ADDENDUM NO. 3

NIAGARA FALLS BRIDGE COMMISSION

RAINBOW BRIDGE DECK REPAIRS AND MISCELLANEOUS REPAIRS AT THE WHIRLPOOL RAPIDS AND LEWISTON-QUEENSTON BRIDGES

PROJECT #2016-02-2A

SHEET REFERENCE NUMBER
RB-107
SHEET 10 A3 OF 29

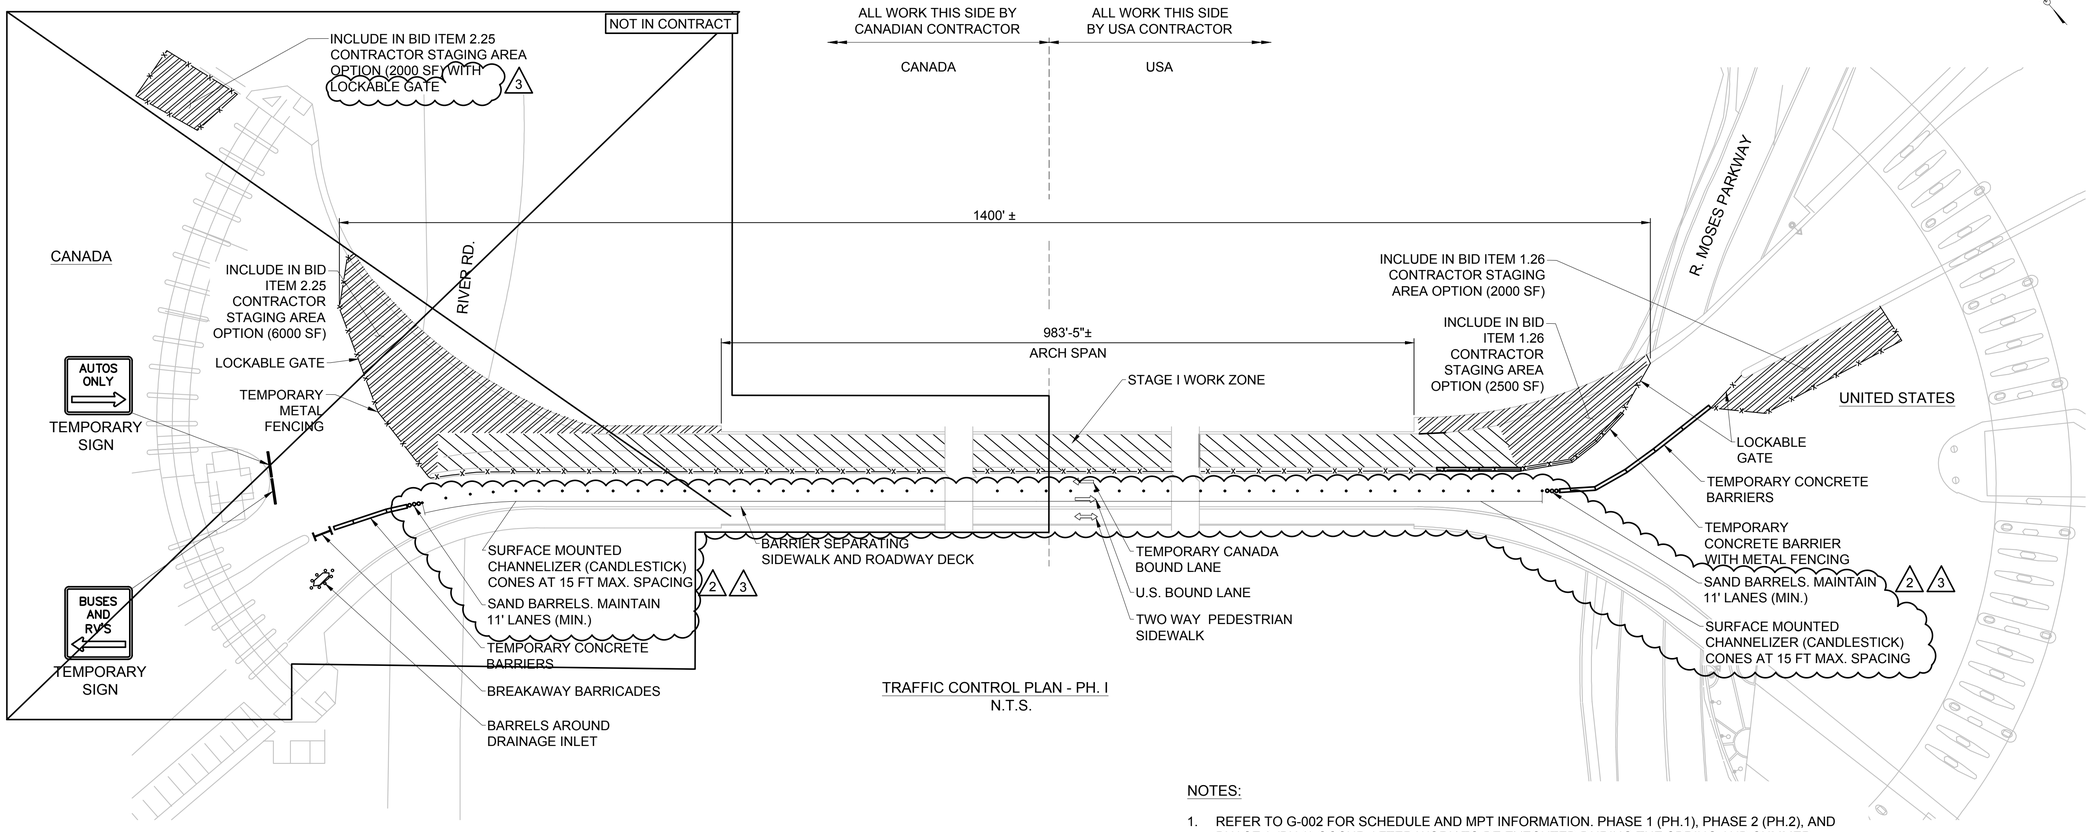
MARK	DESCRIPTION	DATE	APPR.
3	ADDENDUM 3 - GROUT PATCH	1/12/18	SC

2.18.1 Yes replace the approx. 2"-3" grout patch with MGKrete per manufacturer's recommendations.

SHEET REFERENCE NUMBER
RB-111
SHEET 12 A3 OF 29

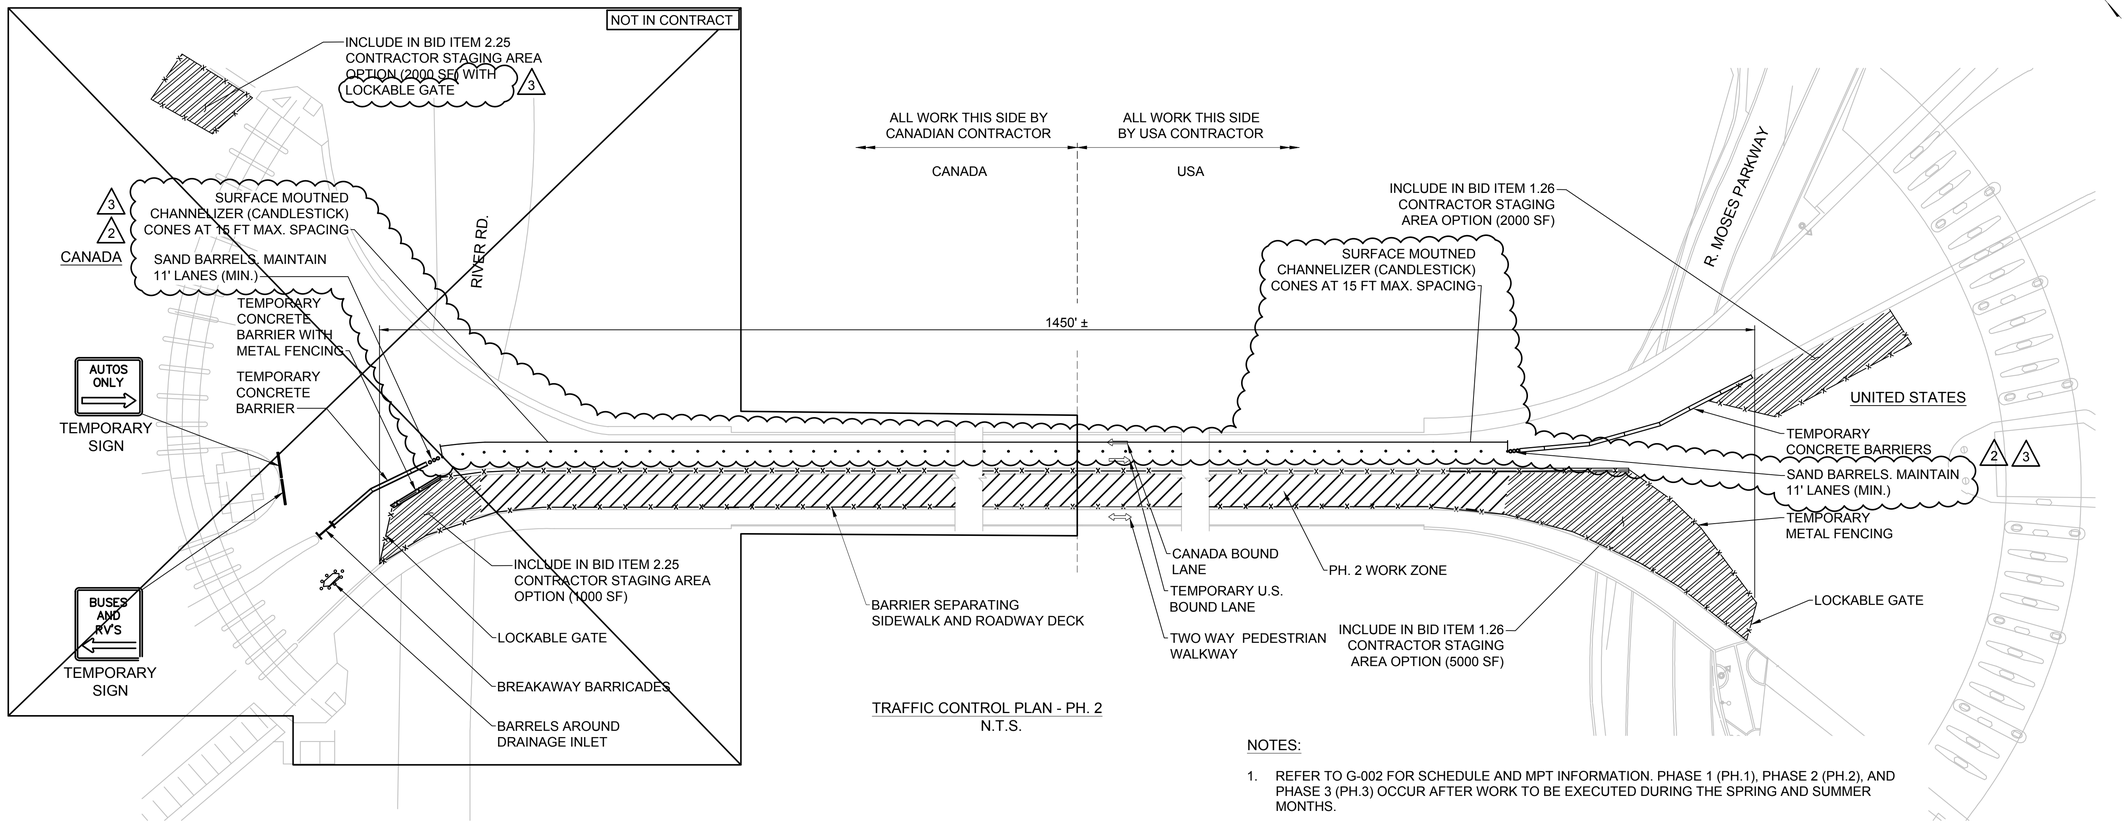
2.2 How will the contractor end the temporary barriers?
- 2.2.1 Sand barrels per NYSDOT 619 for posted speed limit can be used in lieu of a steel crash attenuator. See revised MPT (Maintenance and Protection of Traffic) plans RB-111, RB-112, RB-113

1 RB101 DETAIL - SIDEWALK UTILITY HAND HOLE REPAIRS (TYP.)

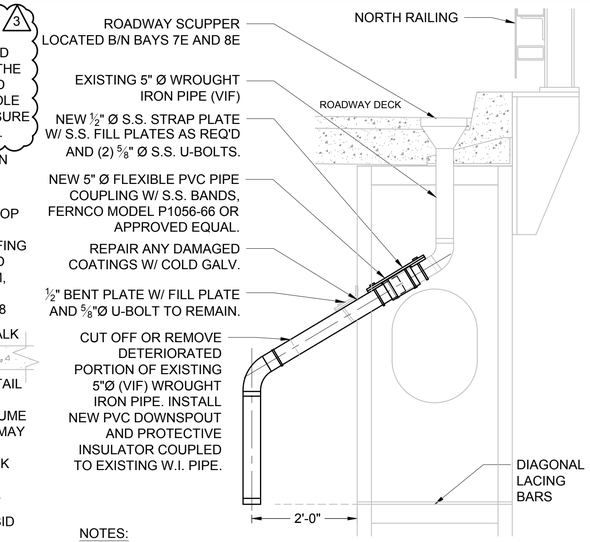
2.15.1 No, sidewalk plates (detail 5/RB503) and utility hand hole diamond plate covers (detail 1/RB502) both get anti-slip coating (Slip-not, Galvagrit, or approved equal) and then hot dip galvanizing.
